# Value Planning Report

## Plan Formulation Project South Utah & Juab County, UT

Workshop Dates: June 24-28, 2024  
Report Date: October 29, 2024

Final  
Value Engineering Study Report  
for

Alternative No.: DW-09

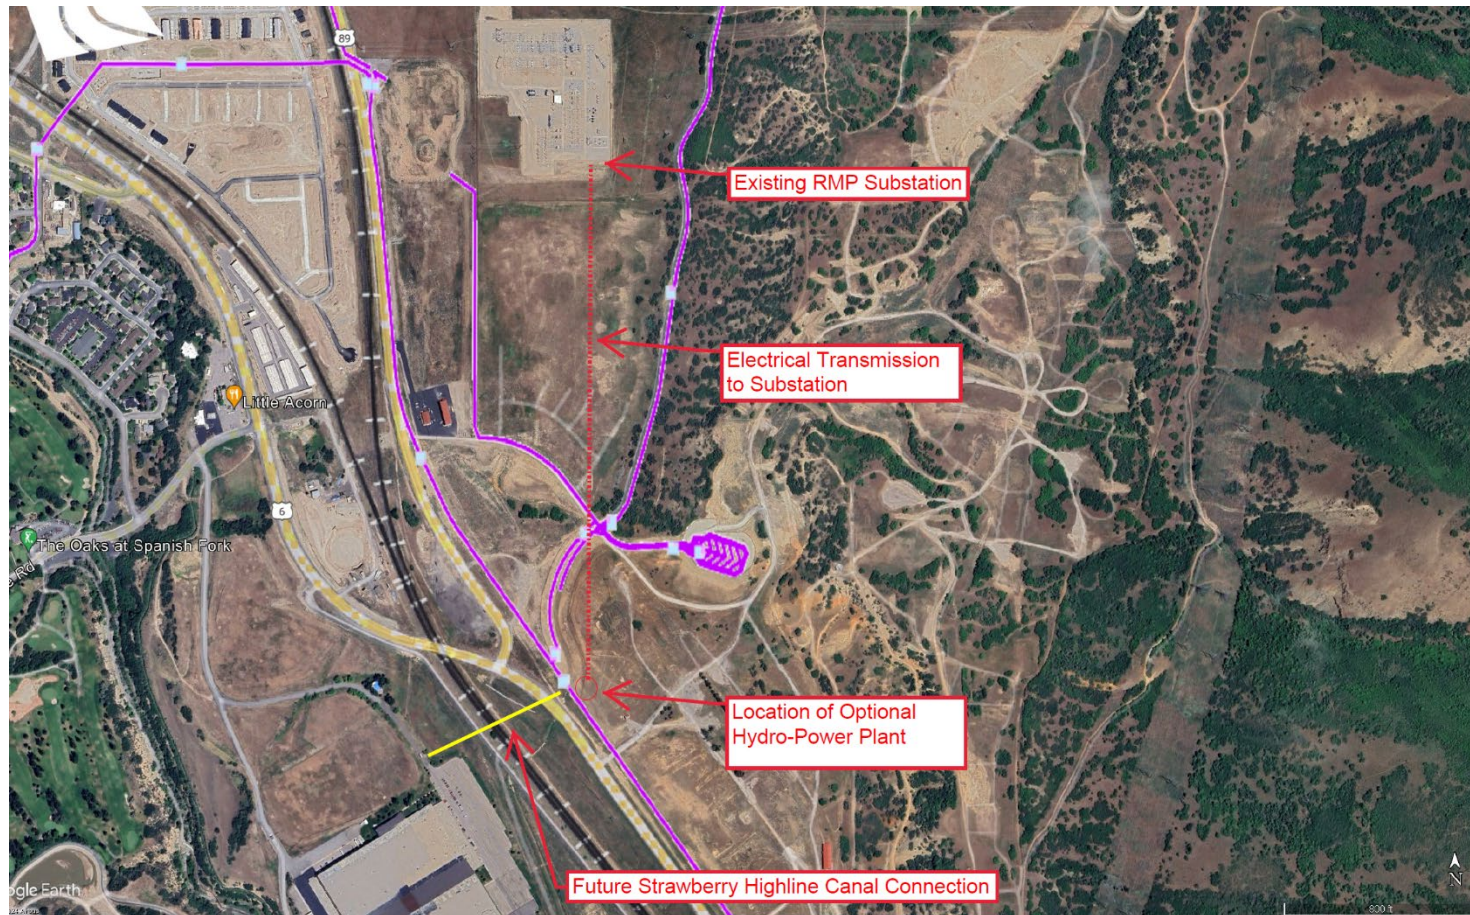
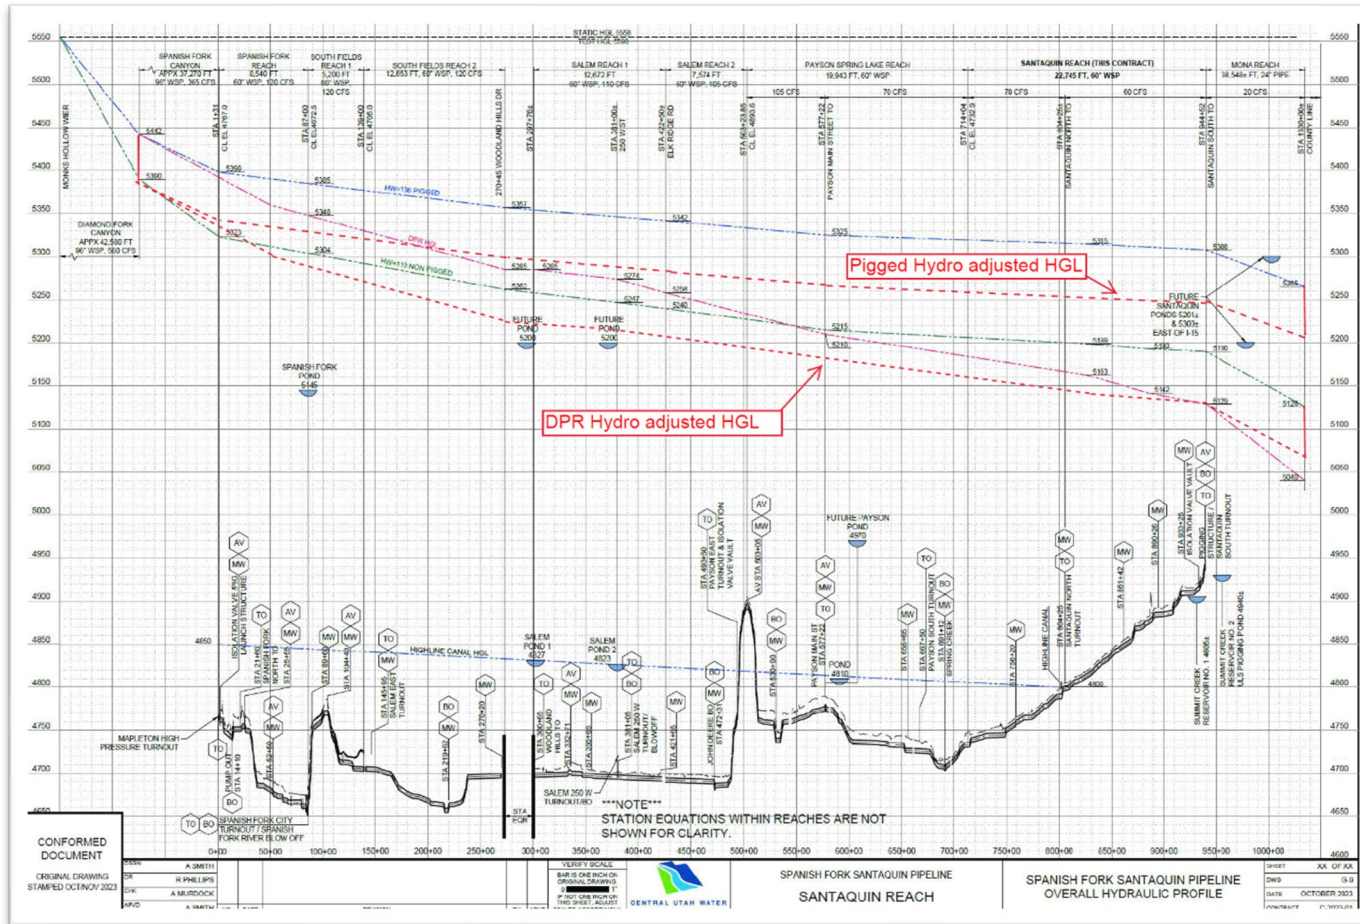
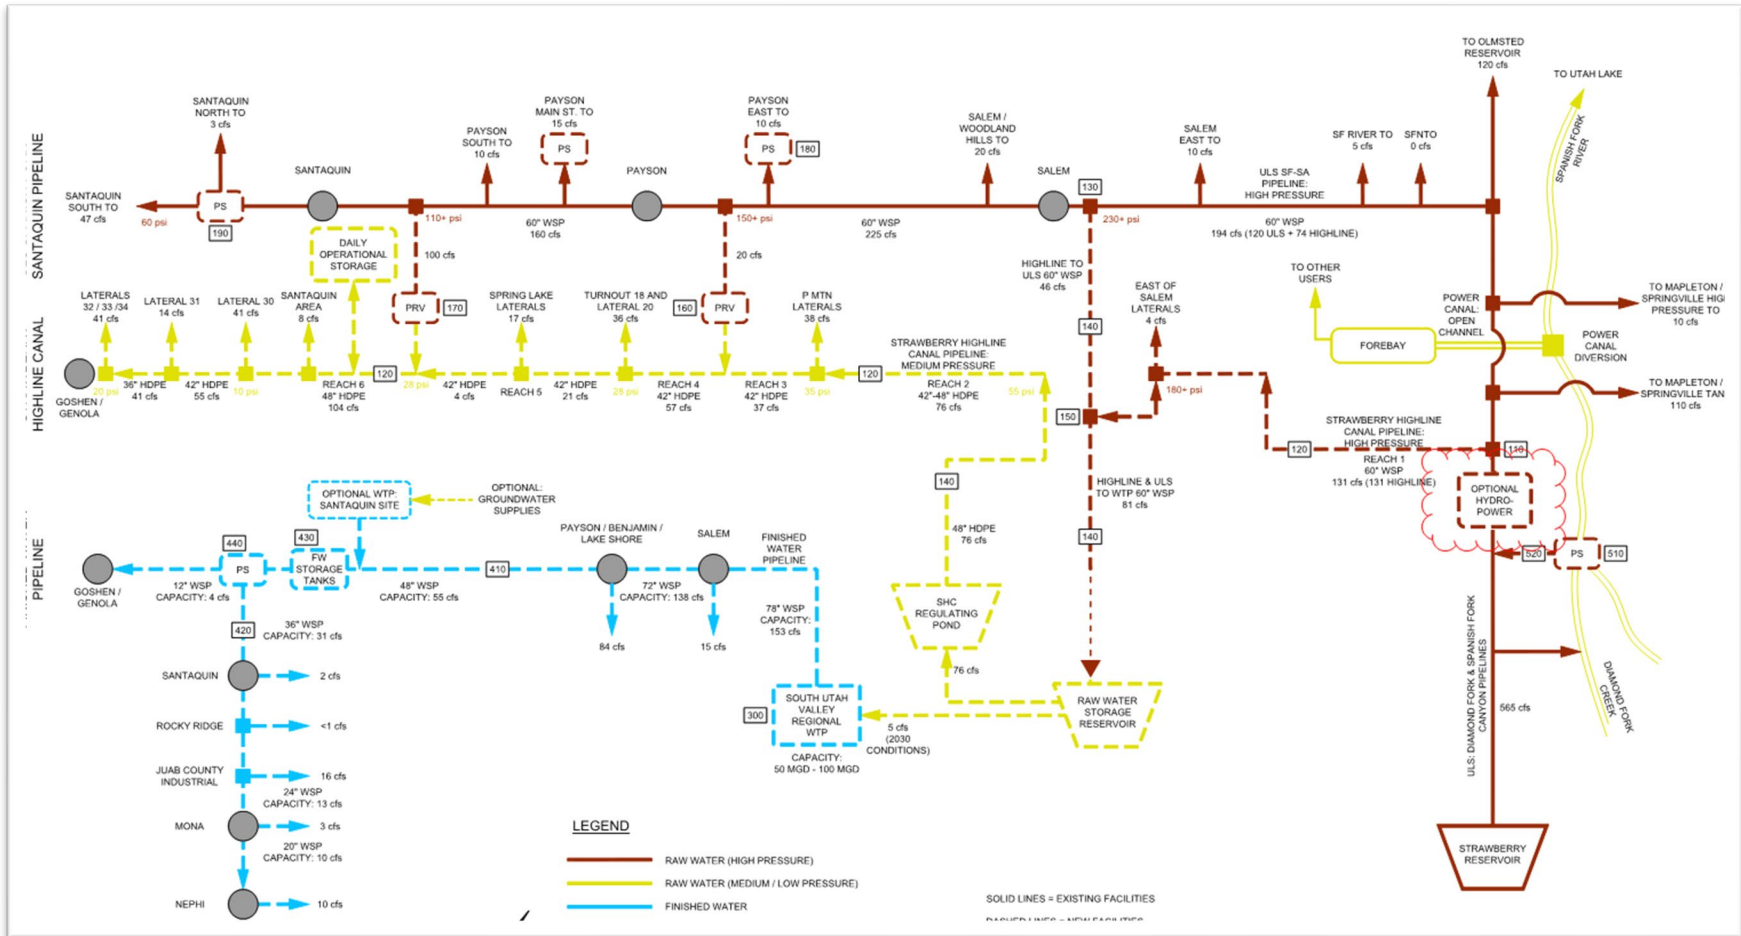
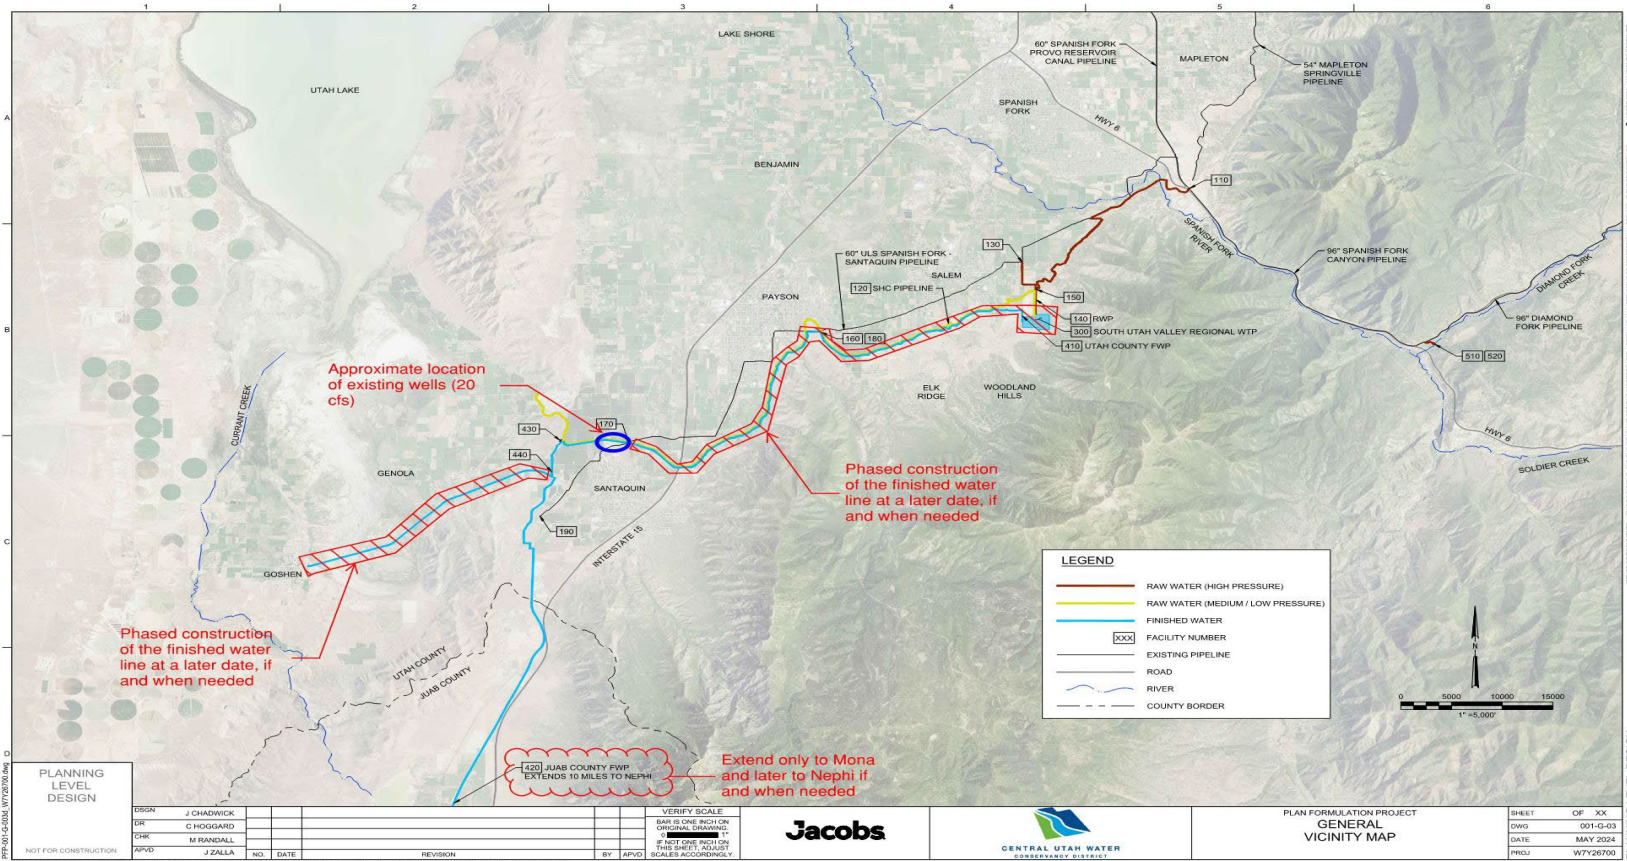
An Energy Market Feasibility Study is essential to assess the viability of integrating hydropower into the water delivery system. This study will involve developing an estimated flow pattern for water deliveries and the subsequent power generation pattern. It will also determine the amount of energy consumed by the District versus the amount available for distribution. Additionally, the study will evaluate the energy market to identify potential electrical customers for excess power generation, which could help fund the project. Another critical aspect is evaluating the costs and feasibility of electrical grid interconnection.

If the study deems the project feasible, several steps must follow. Firstly, a suitable site needs to be selected, potentially on existing easements or federal land (a concept sketch is attached). Transmission line routing and interconnections must be planned, noting there is an RMP substation approximately 0.75 miles from the proposed site. Collaboration with federal partners and considerations under the National Environmental Policy Act (NEPA) will be necessary. Additionally, contracts must be executed with energy utilities to handle power distribution and wheeling back to the SUVR WTP. Finally, the design and construction of the new hydropower facility will be undertaken.

Alternative No.: IS-13

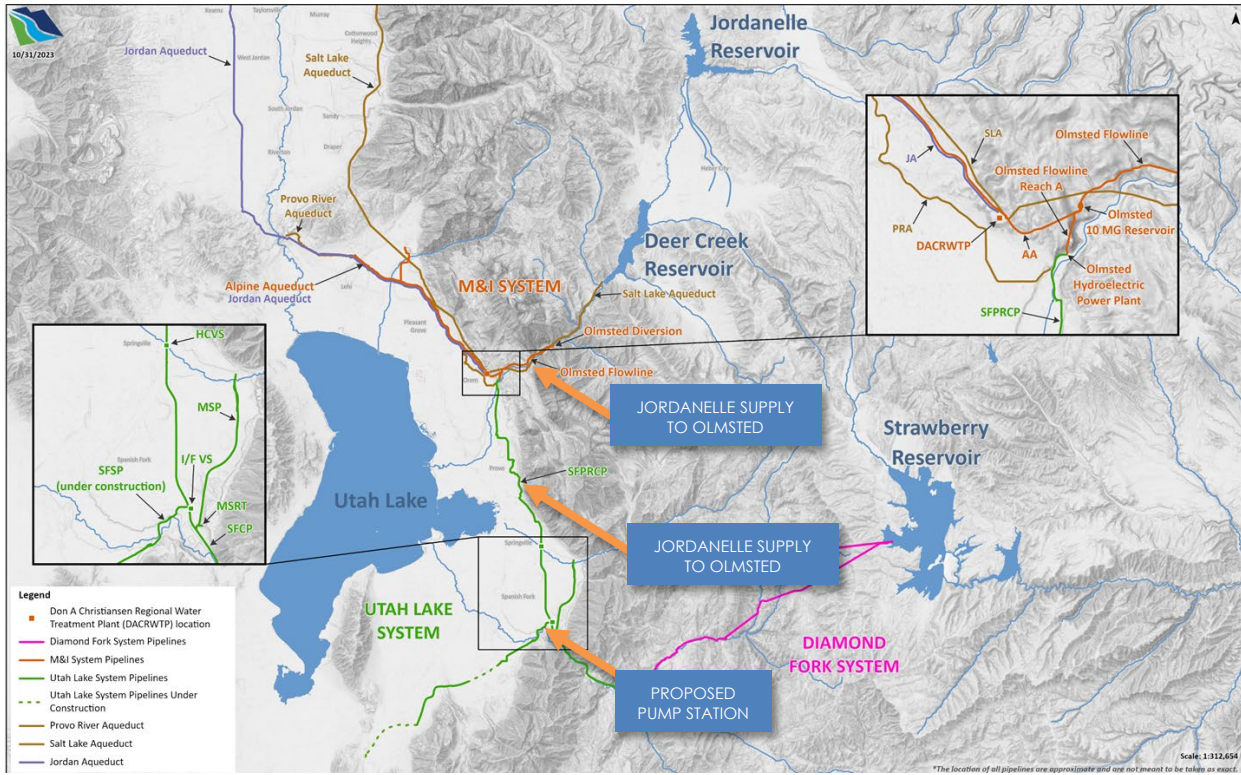
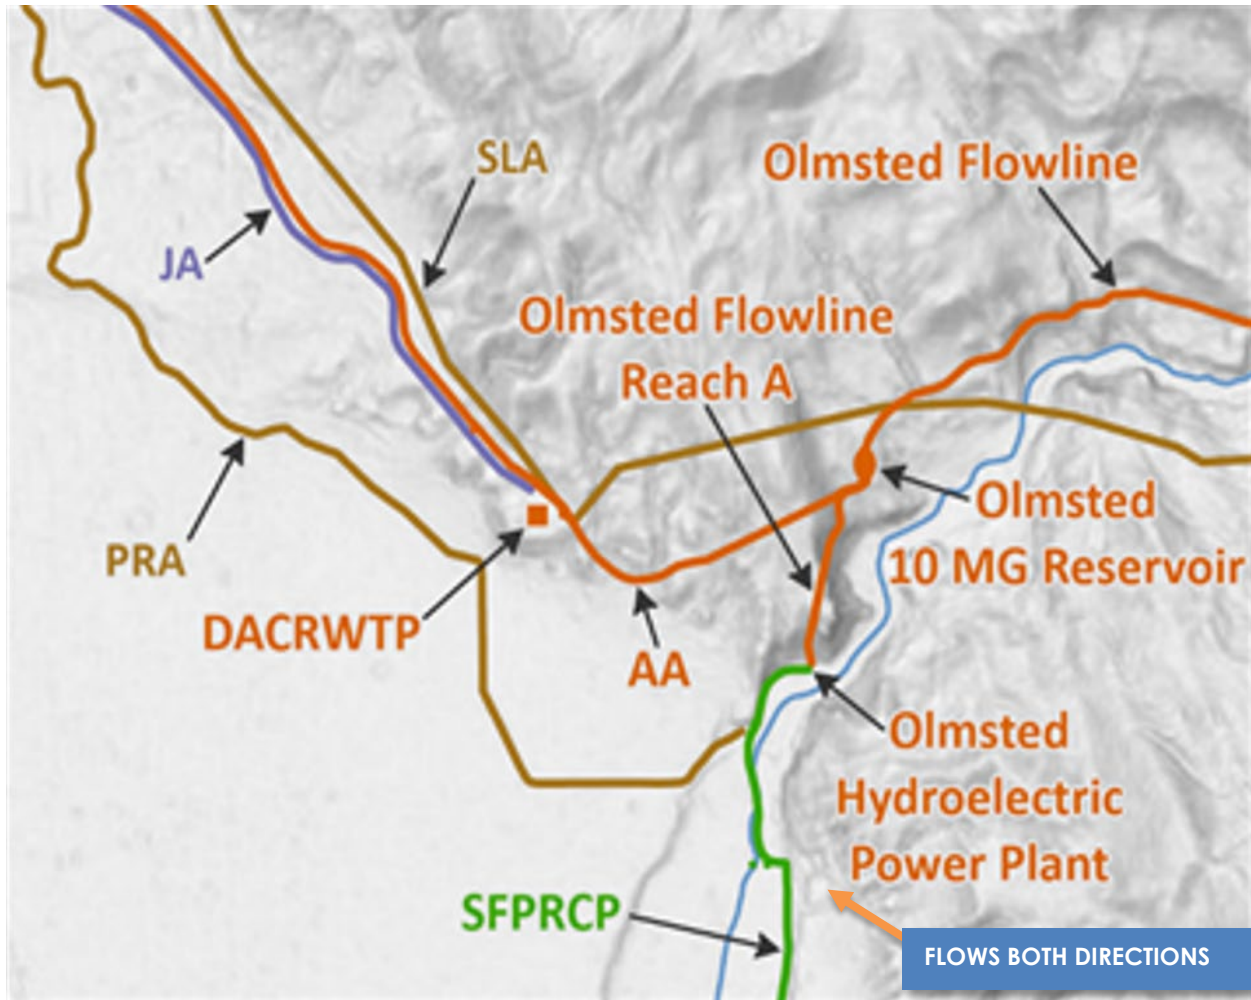
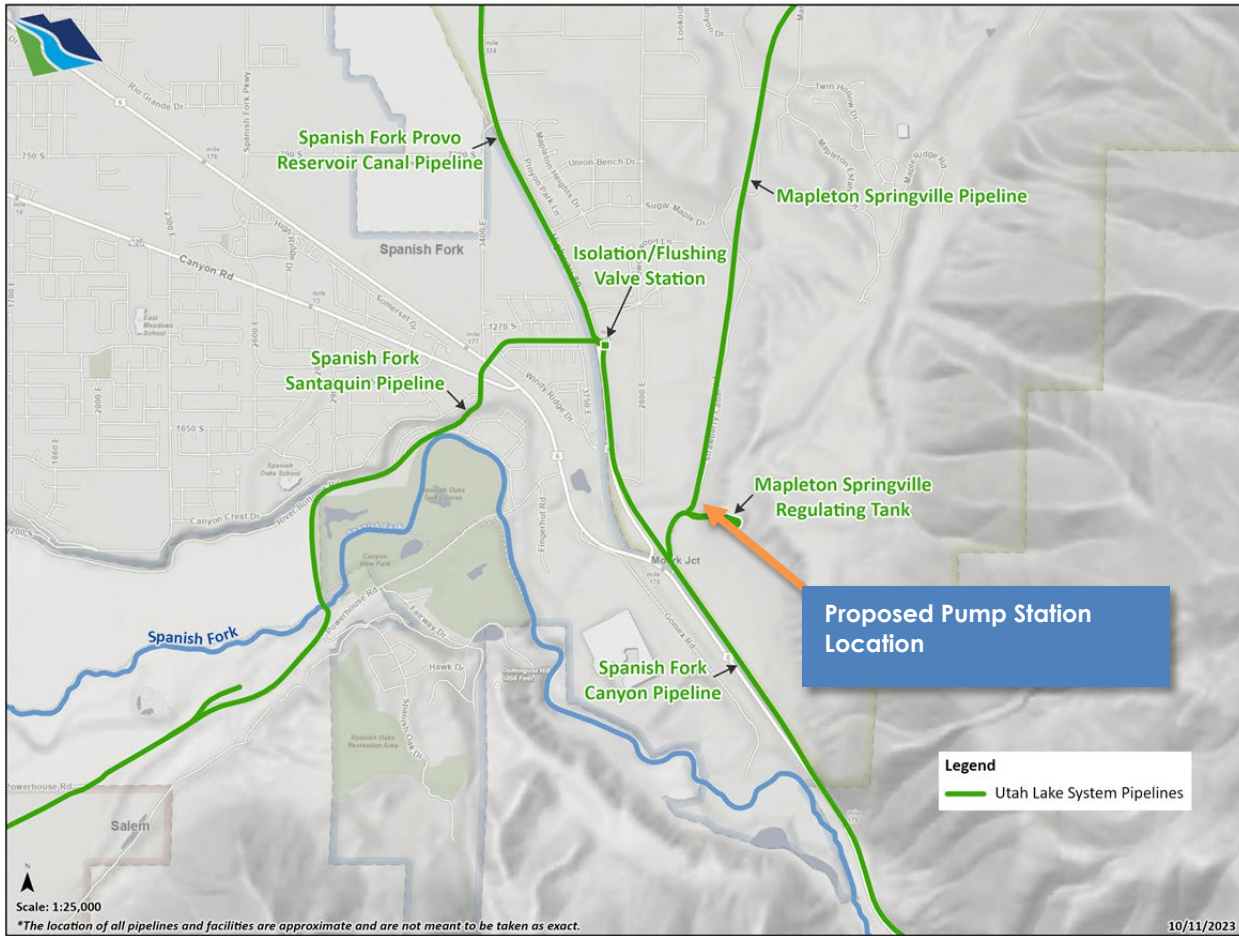
IS-13  
Construct a pump station on the Spanish Fork Provo Reservoir canal to pump water to a water treatment plant for treatment ..... 4-46

To implement, it is necessary to evaluate the impact on the ULS Environmental Impact Statement and identify any required revisions. A hydraulic analysis of the Spanish Fork Santaquin Pipeline should be completed to ensure sufficient head is available to deliver water from Olmsted to the Mapleton Springville regulating tank, and to confirm the availability of land for the pump station at this location. Additionally, refining the preliminary cost estimate and determining the design schedule of the SUVR WTP is essential to align the pump station with that schedule.

Alternative No.: TW-10

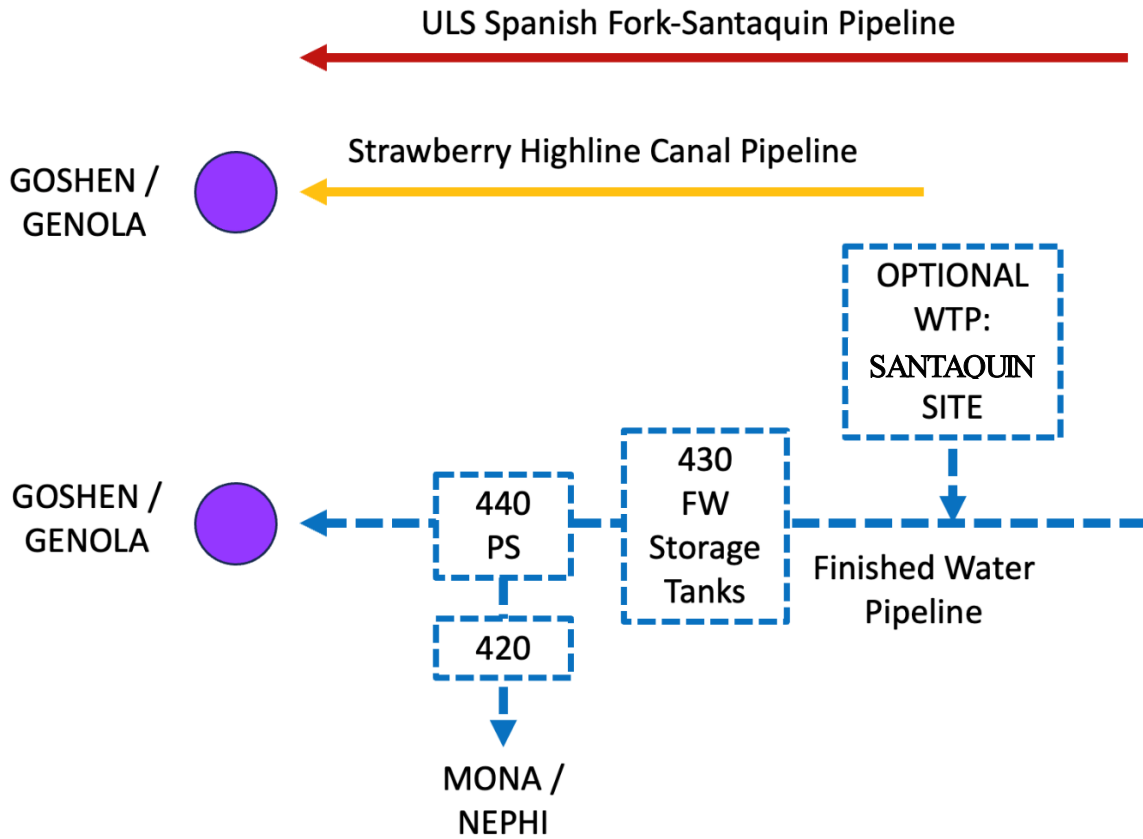
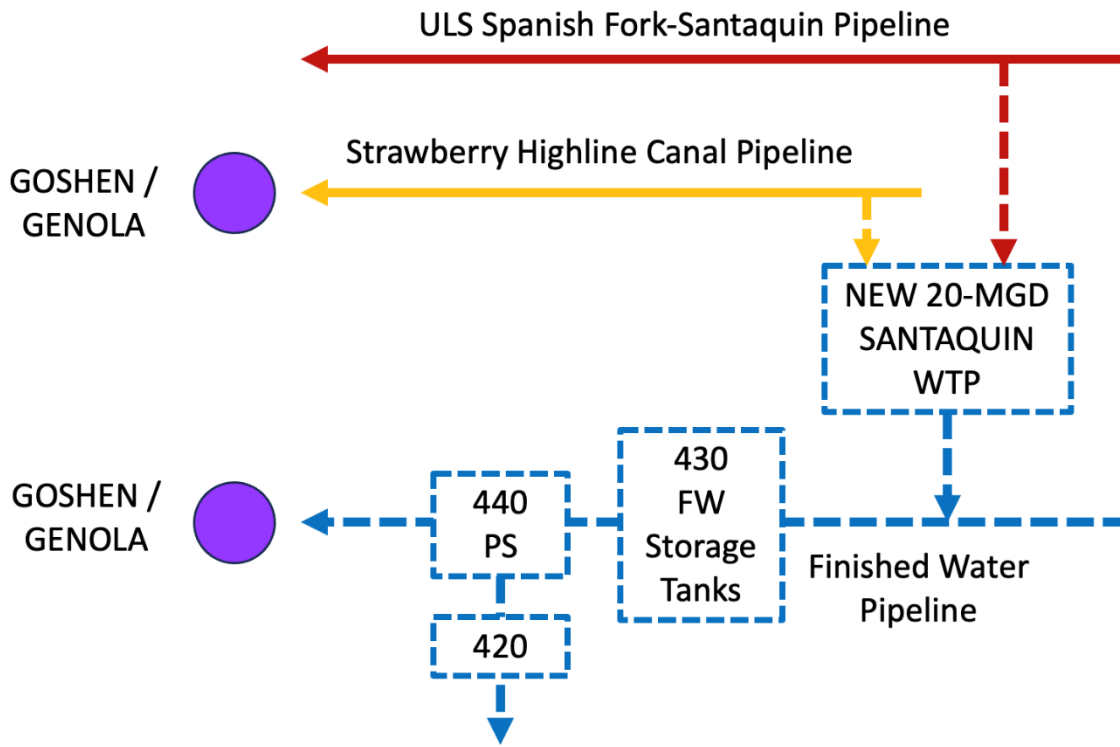
TW-10  
Construct a Santaquin Water Treatment Plant in Phase 1 and construct Salem Water Treatment Plant at a future date ..... 4-56

This alternative is intended to be consistent with the current planning for water treatment facilities, applied to the option indicated in the Proposed System Configuration (TM2, Figure 5-1). The assumption was made that the operating costs would be comparable regardless of the location of the treatment plant.
